# DART SERVICE INSTRUCTION

TO AMEND INSTALLATION INSTRUCTIONS IIN-D350-822 REV. H AND INSTRUCTIONS FOR CONTINUED AIRWORTHINESS ICA-D350-822 REV. 6 OR LATER APPROVED REVISION

REF. TCCA STC: SH14-14  
REF. FAA STC: SR03538NY  
REF. ANAC STC: 2014S07-11  
REF. JCAB STC: STC-372-OSA/STC-371-OSA  
REF. EASA STC: 10056574

**Figure 1 - QB21308 Assembly Screen**

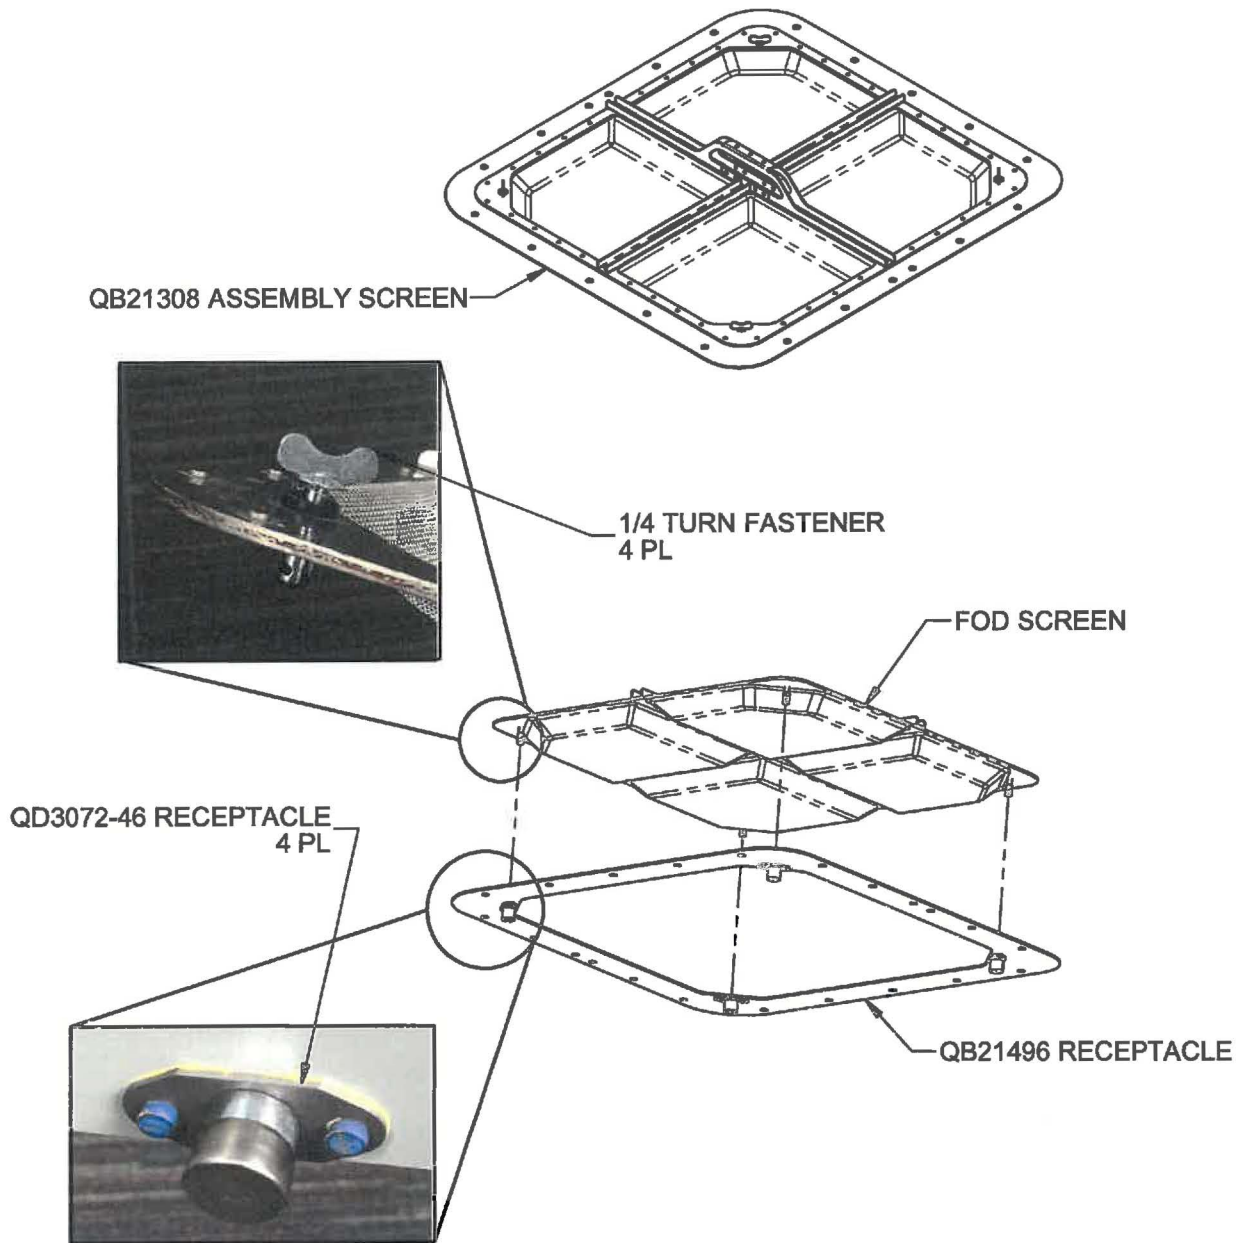
- 2.1.3 Separate the FOD screen from the QB21496 Receptacle by turning the 1/4 turn fasteners and lift the FOD screen per Figure 1.
- 2.1.4 Drill out the retaining rivets and remove qty(4) QD3072-46 Receptacles from the QB21496 Receptacle. Remove any adhesive residue.

- NOTE: Although not generally necessary, it is acceptable to use longer or shorter MS20426AD3-X Rivets
- 2.1.8 Remove qty(4) 1/4 Turn Fasteners from the FOD Screen per Figure 1.

**Figure 2 - DSI 9815-011 Replacement Receptacle Kit**

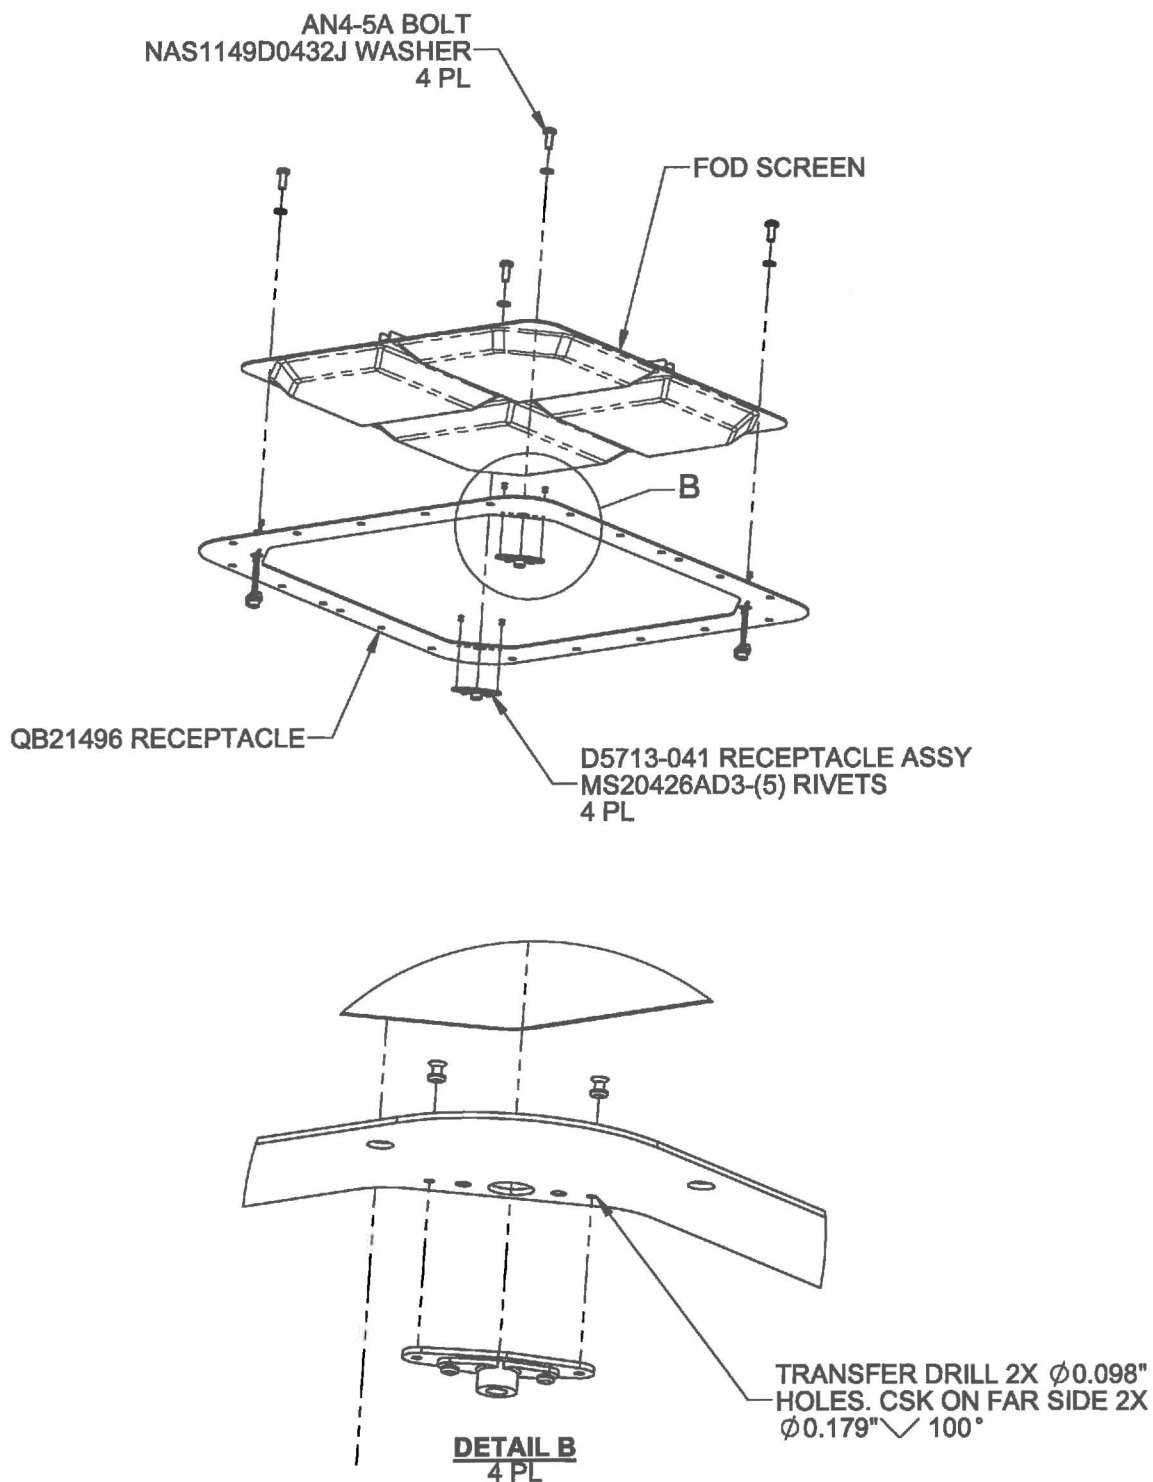
- 2.1.5 Position the qty(4) D5713-041 Receptacle Assy in the location shown in Figure 2. Transfer drill 2x  $\varnothing 0.098$ " holes with CSK  $\varnothing 0.179$ "  $\angle 100^\circ$  on the top side from the D5713-041 Receptacle Assy to the QB21496 Receptacle. Touch up holes with Alodine 1200 per MIL-C-5541.

- 2.1.6 Mask nutplate holes and touch up the affected areas with prime and paint per ICA-D350-822.
- 2.1.7 Install qty(4) D5713-041 Receptacle Assy with qty(2) MS20426AD3-(5) Rivets per Figure 2.

- 2.1.9 Reinstall the FOD screen on the QB21496 Receptacle using qty(4) AN4-5A bolts and qty(4) NAS1149D0432J Washers per Figure 2. Torque bolts to 50-70 in-lb (5.6-7.9 N-m).

2.3.2 Install the FOD Screen with qty(4) AN4-5A bolts and qty(4) NAS1149D0432J Washers per Figure 2.
